26 October 2000

Re: Question from the FCC

FCC ID: O3JF2R802D1
Correspondence Reference Number: 16077
731 Confirmation Number EA98661
Date of Original E-Mail: 9/13/2000

Figure 1 Keyboard Up with antenna out

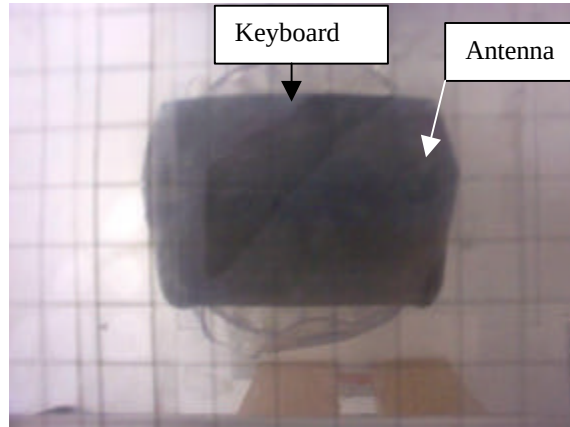
> 4. Table in Section 6.2(4) of the SAR report indicates a number of
SAR test configurations, please provide illustrations to distinguish
the difference between "keyboard up" and "top side up" configurations.

The following two figures illustrate these two positions. The "Keyboard Up" scans were performed with the device's keyboard place against the bottom of the phantom (Figure 1).

The “Top Side Up” scan was performed with the top of the point of sale device against the bottom of the phantom with the antenna in. This scan was performed to check on the SAR in the direction of a bystander in front of the user.

Figure 3. Zoom on 25% duty factor separation curve

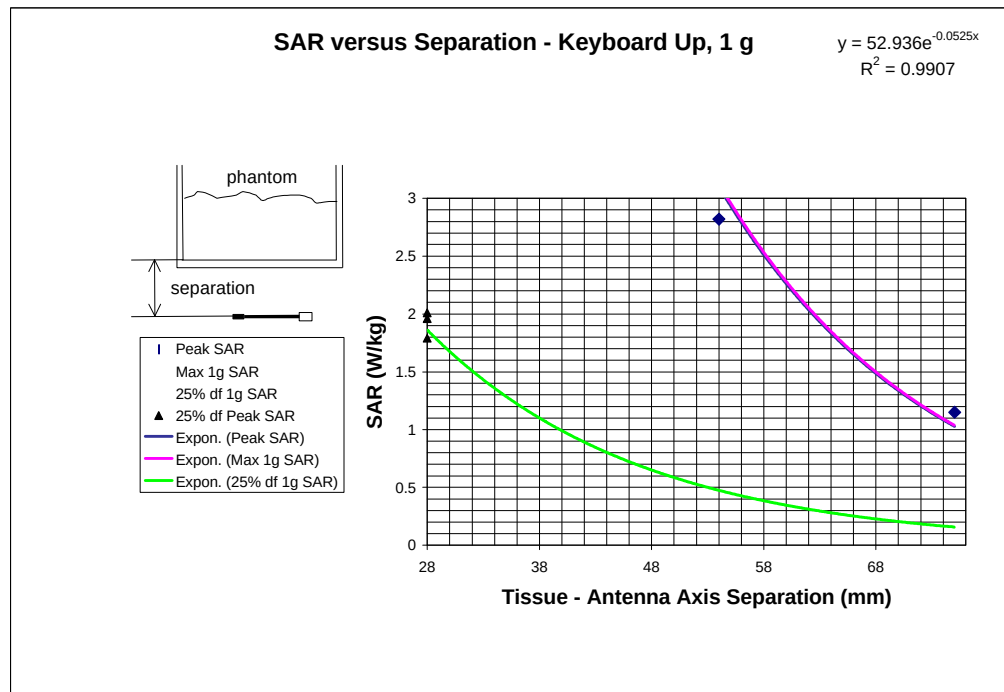
> 6. Please review figure 14 and explain/verify that the separation distance extrapolation procedures used for 1-g SAR based on 100% duty data can be applied to 25% situations according to the measurement made at 25% duty factor (1.85 W/kg).

Ideally it would have been best to have taken all the measurements at 25%, however, since one complete set of measurements were already taken at 100%, this was not considered necessary (at the time the original 100% duty factor measurements were made RIM had not decided what duty factor they were going to limit all modems to). By making one accurate measurements at 25% we can calculate the other quantities of interest by the appropriate proportional scaling. (In the future all RIM modems will have the 25% duty factor firmware factory installed and the full array of testing will be performed with a 25% duty factor, for all devices using these modems).

In the case of bystander separation we can estimate from the 100% data what we would expected at 25%. The maximum 1g SAR was determined to be 1.40W/kg with a 100% duty factor and a separation of 41.3mm between the surface of the DUT and the phantom (there is an additional 28mm between the phantom and the antenna for a total 69.3mm separation). Since SAR is to first order linearly proportional to average power we would anticipate that the maximum 1g SAR with a 25% duty factor would be $0.25 \times 1.40\text{W/kg}$, or 0.35W/kg, which is about one 5th of the 1.6W/kg limit. This compares well with the 0.23 W/kg determined, which is about one 7th of the 1.6W/kg limit.

Figure 3 (below) presents a zoomed in view of Figure 14 from the report. Note that the 28mm on the x-axis corresponds to the surface of the DUT being in contact with the phantom; 40mm would correspond to the antenna axis being 40mm from the simulated tissue boundary within the phantom (12mm from surface of DUT facing phantom); and 68mm on the x-axis would correspond to the DUT surface facing the phantom being 40mm from the tissue boundary. From the figure we see that at 40mm from the DUT surface the maximum 1g average SAR would be 0.23W/kg while at 40mm from the antenna axis (12mm from DUT surface) the maximum 1g average SAR would be 0.99W/kg. Consequently, if the user keeps the device at least 4cm (1 ½ inches) away from bystander, then the bystander will not be exposed to SAR levels exceeding the FCC health and safety guidelines.
